## PRODUCT CHANGE NOTIFICATION (PCN)

### A-MCSP-80150 MODULAR CABLE

CHANGE NOTIFICATION: PCN 20220425\_A-MCSP-80150

DESCRIPTION OF CHANGES: CHANGE OF DATA SHEET  
CHANGE OF DATA SHEET  
New Draw.-No. ASS\_0841\_CAreV01

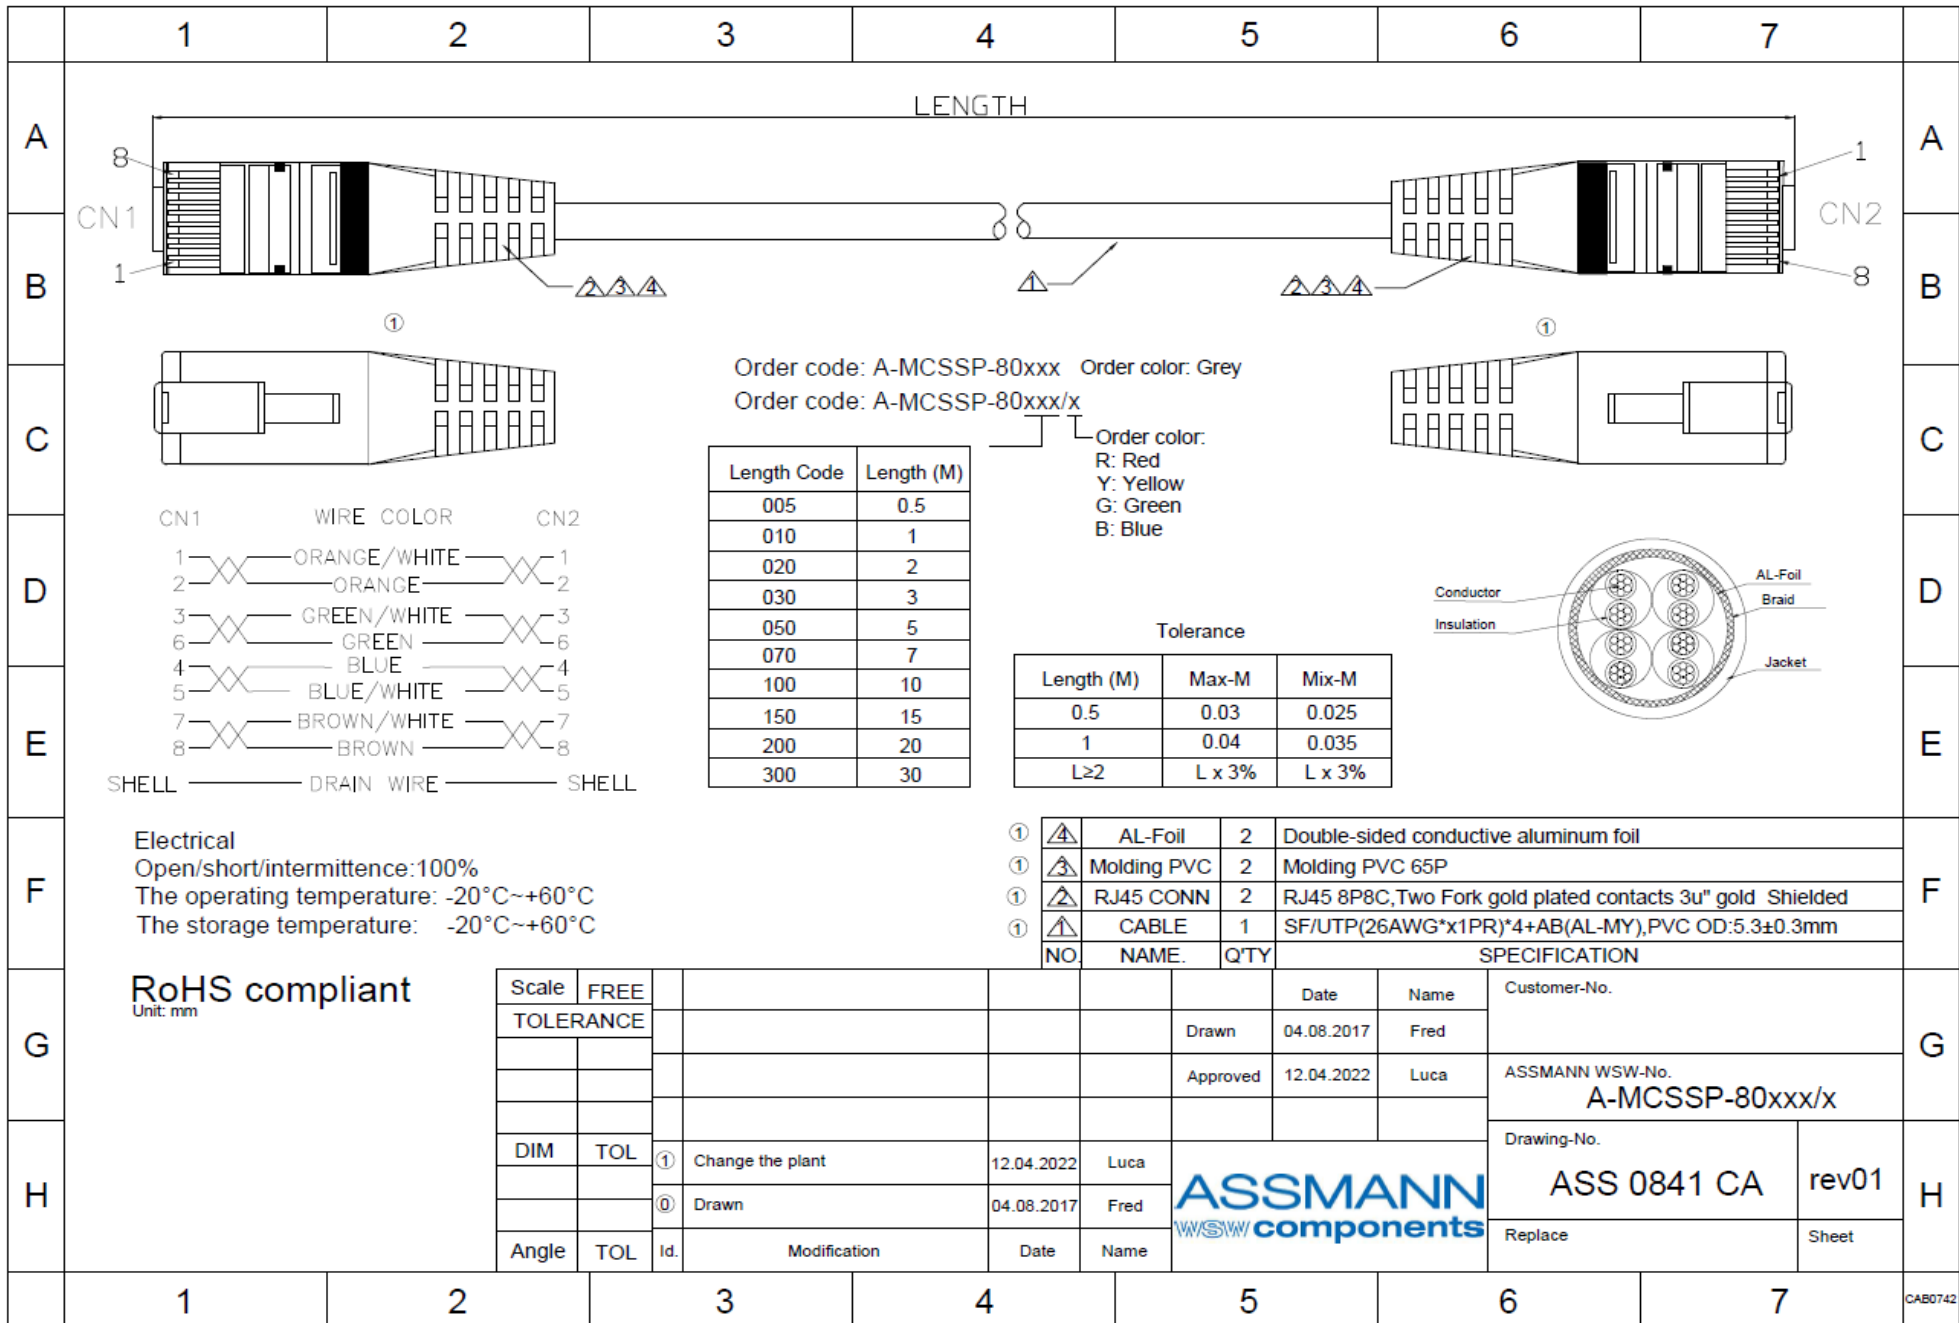
REASON FOR CHANGE: CHANGE OF PRODUCT LOCATION  
CHANGE OF PRODUCT LOCATION

A-MCSSP-80150	OLD VERSION	A-MCSSP-80150	NEW VERSION																																				
<p>Appearance</p>		<p>Appearance</p>																																					
<p>BOM</p> <table border="1"> <thead> <tr> <th>NO.</th> <th>NAME.</th> <th>Q'TY</th> <th>SPECIFICATION</th> </tr> </thead> <tbody> <tr> <td>③</td> <td>Molding PVC</td> <td>2</td> <td>Molding PVC 45P</td> </tr> <tr> <td>②</td> <td>RJ45 CONN</td> <td>2</td> <td>RJ45 8P8C,Two Fork gold plated contacts 3u" gold</td> </tr> <tr> <td>①</td> <td>CABLE</td> <td>1</td> <td>SFTP(26AWG*x1PR)*4+AB,PVC OD:5.3±0.3mm</td> </tr> </tbody> </table>		NO.	NAME.	Q'TY	SPECIFICATION	③	Molding PVC	2	Molding PVC 45P	②	RJ45 CONN	2	RJ45 8P8C,Two Fork gold plated contacts 3u" gold	①	CABLE	1	SFTP(26AWG*x1PR)*4+AB,PVC OD:5.3±0.3mm	<p>BOM</p> <table border="1"> <thead> <tr> <th>NO.</th> <th>NAME.</th> <th>Q'TY</th> <th>SPECIFICATION</th> </tr> </thead> <tbody> <tr> <td>①</td> <td>AL-Foil</td> <td>2</td> <td>Double-sided conductive aluminum foil</td> </tr> <tr> <td>①</td> <td>Molding PVC</td> <td>2</td> <td>Molding PVC 65P</td> </tr> <tr> <td>①</td> <td>RJ45 CONN</td> <td>2</td> <td>RJ45 8P8C,Two Fork gold plated contacts 3u" gold Shielded</td> </tr> <tr> <td>①</td> <td>CABLE</td> <td>1</td> <td>SF/UTP(26AWG*x1PR)*4+AB(AL-MY),PVC OD:5.3±0.3mm</td> </tr> </tbody> </table>		NO.	NAME.	Q'TY	SPECIFICATION	①	AL-Foil	2	Double-sided conductive aluminum foil	①	Molding PVC	2	Molding PVC 65P	①	RJ45 CONN	2	RJ45 8P8C,Two Fork gold plated contacts 3u" gold Shielded	①	CABLE	1	SF/UTP(26AWG*x1PR)*4+AB(AL-MY),PVC OD:5.3±0.3mm

NO.	NAME.	Q'TY	SPECIFICATION																																				
③	Molding PVC	2	Molding PVC 45P																																				
②	RJ45 CONN	2	RJ45 8P8C,Two Fork gold plated contacts 3u" gold																																				
①	CABLE	1	SFTP(26AWG*x1PR)*4+AB,PVC OD:5.3±0.3mm																																				
NO.	NAME.	Q'TY	SPECIFICATION																																				
①	AL-Foil	2	Double-sided conductive aluminum foil																																				
①	Molding PVC	2	Molding PVC 65P																																				
①	RJ45 CONN	2	RJ45 8P8C,Two Fork gold plated contacts 3u" gold Shielded																																				
①	CABLE	1	SF/UTP(26AWG*x1PR)*4+AB(AL-MY),PVC OD:5.3±0.3mm																																				
<p>FOR DETAIL, PLEASE TAKE ATTACHED NEW DRAWING: FOR REFERENCE</p>

NO	NAME	QTY	SPECIFICATION
①	AL-Foil	2	Double-sided conductive aluminum foil
①	Molding PVC	2	Molding PVC 65P
①	RJ45 CONN	2	RJ45 8P8C, Two Fork gold plated contacts 3u" gold Shielded
①	CABLE	1	SF/UTP(26AWG*x1PR)*4+AB(AL-MY),PVC OD:5.3±0.3mm
